marantz			Date: 16-Mar-2005 Model: ER2500		
			1 / 3	REF.NBR: MZ05-009	
SERVICE BULLETIN			Subject:		
Level	Application:	Sync problem with particular Video equipment.			
**	See below				
		Int.ref:

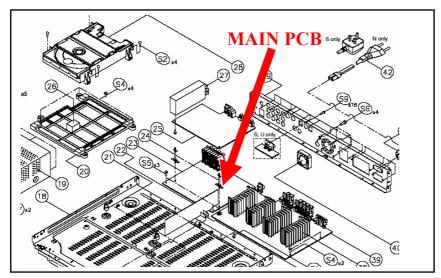
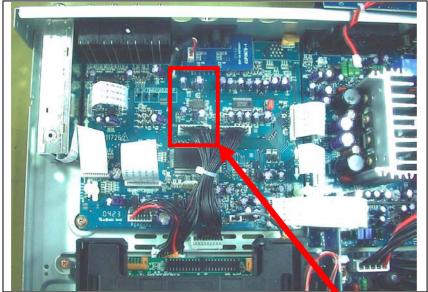
The following 6pcs of parts are changed on the MAIN PCB As for the details, Please see page2/3 and 3/3.

- 1. POS.NO C531 CHIP ELECT. CAPACITOR (100uF 16V) is changed to (33uF 16V).
- 2. POS.NO C537 CHIP ELECT. CAPACITOR (100uF 16V) is changed to (33uF 16V).
- 3. POS.NO CARBON FILM FIXED RESISTOR (75 OHM +-5% 1/6W) is added.
- 4. POS.NO CARBON FILM FIXED RESISTOR (75 OHM +-5% 1/6W) is added.
- 5. POS.NO R525 CHIP RESISTOR (75 OHM) is removed.
- 6. POS.NO R530 CHIP RESISTOR (75 OHM) is removed.

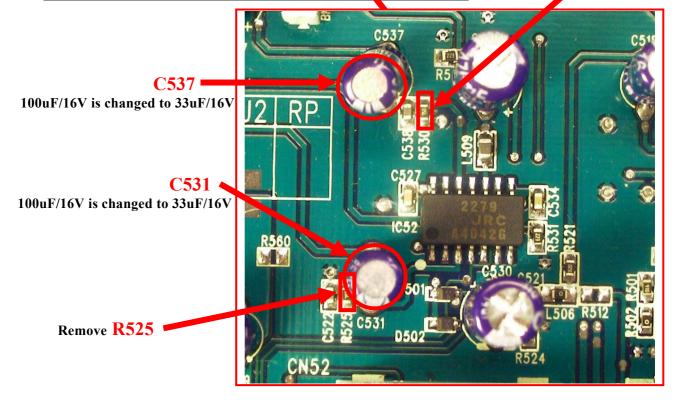
Remove R530
